SECOND AND THIRD FLOOR FRAMING PLAN

WAR DEPARTMENT QUARTERMASTER CORPS CONSTRUCTION SERVICE
FORT BENNING, GA
CUARTEL BARRACKS
FOR TWENTY NINTH U S INFANTRY
SECTION A

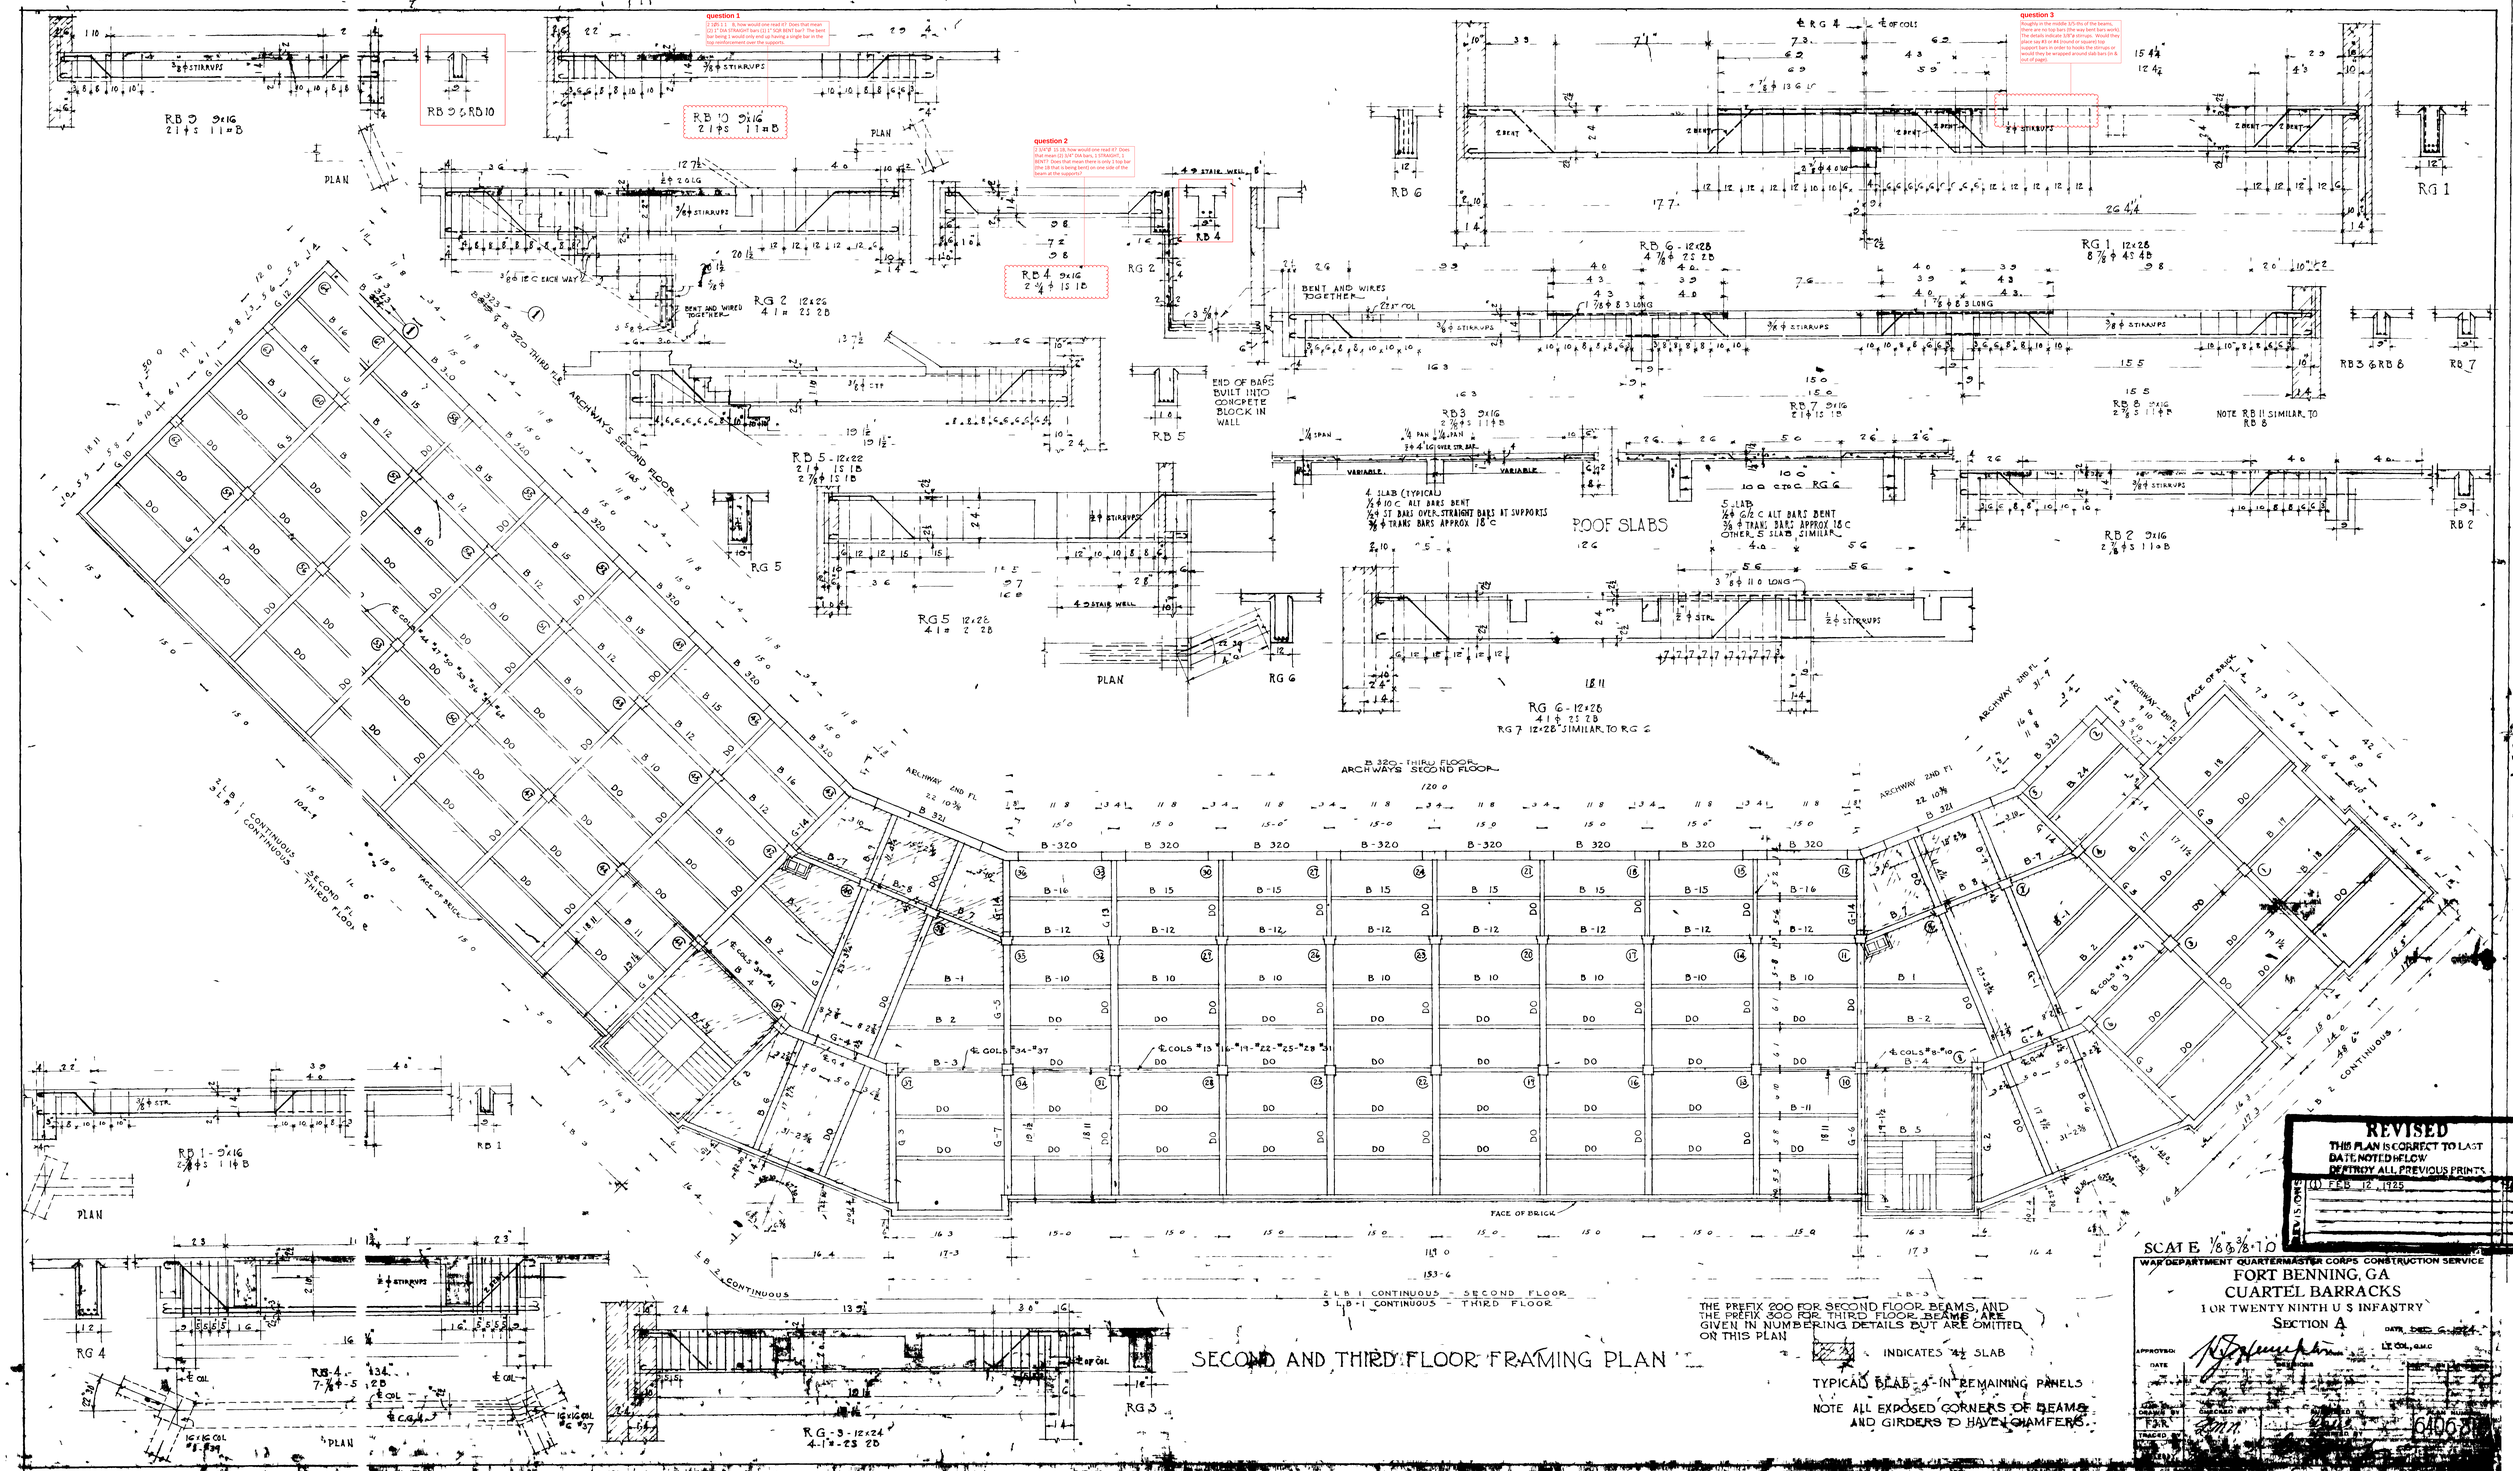
(1 6B-11 - 6) how would one read it? Does that mean (2) 1" DIA STRAIGHT bars (1) 1" SQR BENT bar? The bent bar being 1 would only end up having a single bar in the top reinforcement over the supports.

(1 10"W 10.3)), how would one read it? Does that mean (3) 3/4" DIA bars, 1 STRAIGHT, 2 BENT? Does that mean there is only 1 top bar (the 1B that is being bent) on one side of the beam at the supports?

Roughly in the middle 1/3 rds of the beams, there are no top bars (the way bent bars work). The details indicate 3/8"# stirrups. Would they place say #3 or #4 (round or square) top support bars in order to hooks the stirrups or would they be wrapped around sub bars (in & out of page).
